SYNTHETIC FIBERS
AP-42 Section 5.19
Reference Number
50

Mr. Don R. Goodwin, Director
Emission Standard & Engineering Division
U.S. Environmental Protection Agency
Research Triangle Park
North Carolina 27711

We have received and reviewed your proposed "New Source Performance Standards for Synthetic Fiber Production Facilities" and appreciate the opportunity to provide critical comment prior to final promulgation of these regulations.

MONTHLY TOLUENE RECOVERY
AS A FUNCTION OF CARBON AGE

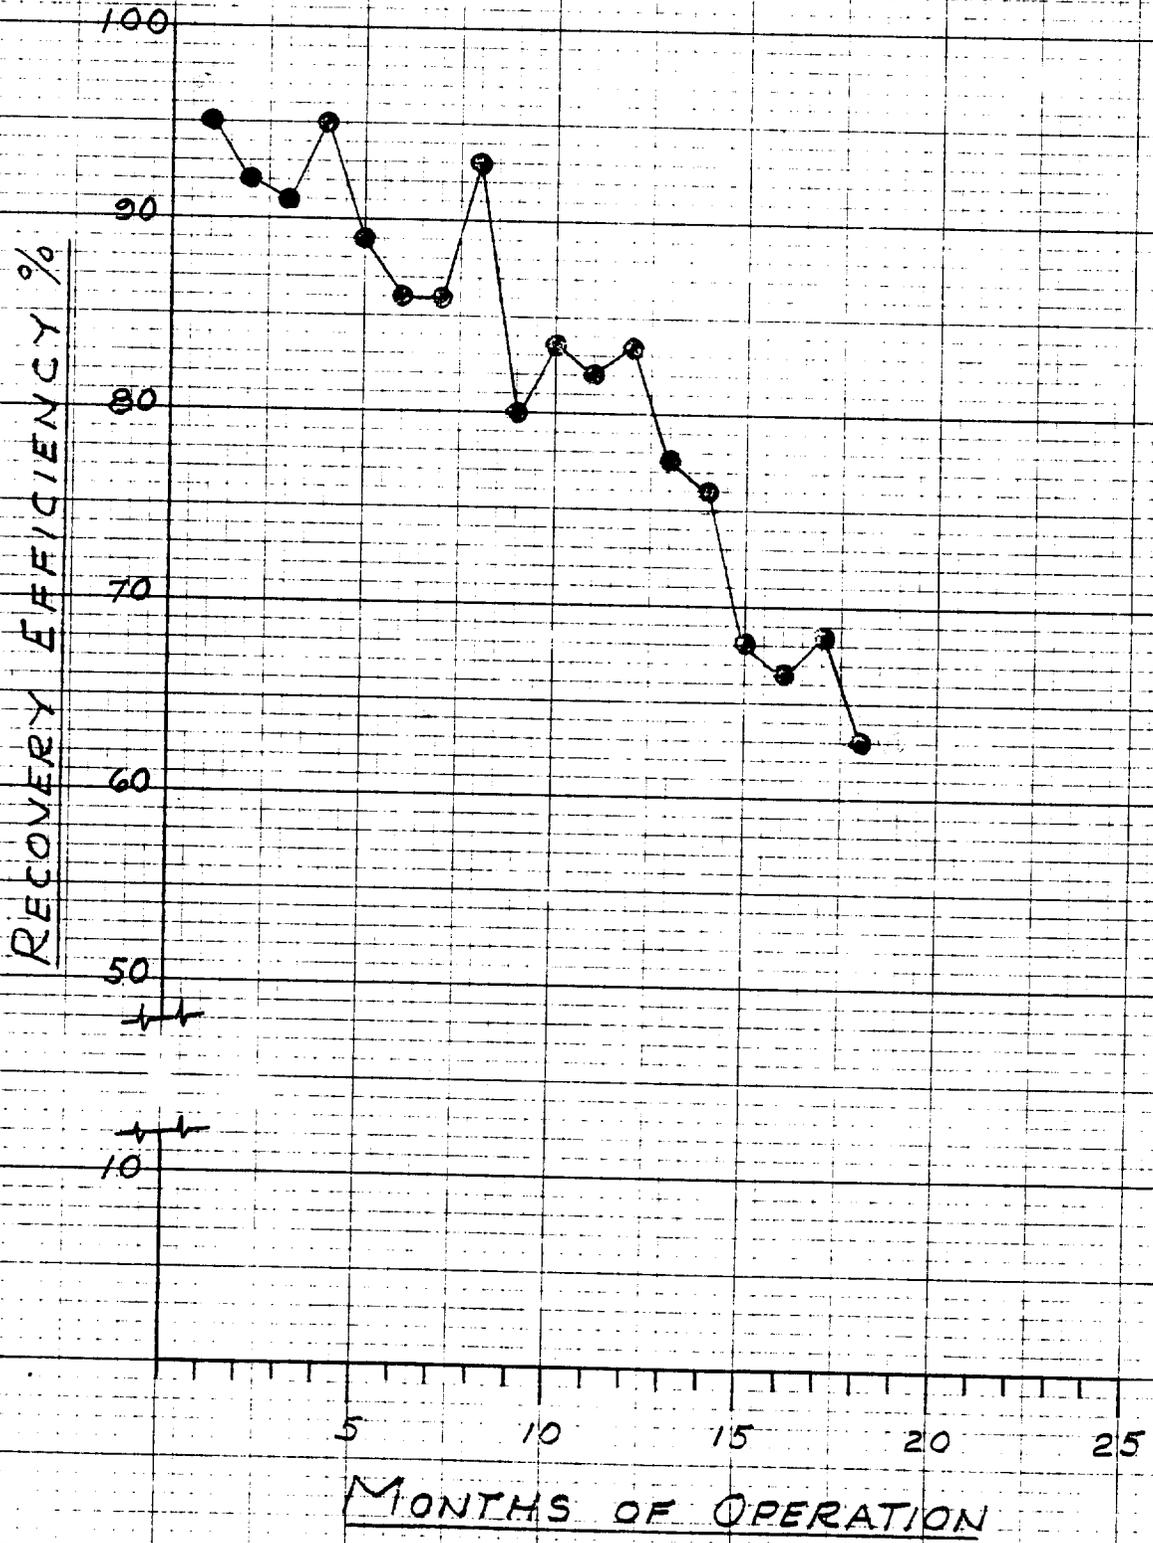
6. Emission rates are based on control devices that are 98% efficient. In our questionnaire response (question 34) we indicated a recovery of about 85% , yet, this was apparently also disregarded when the NSPS models were developed by P.E.S.
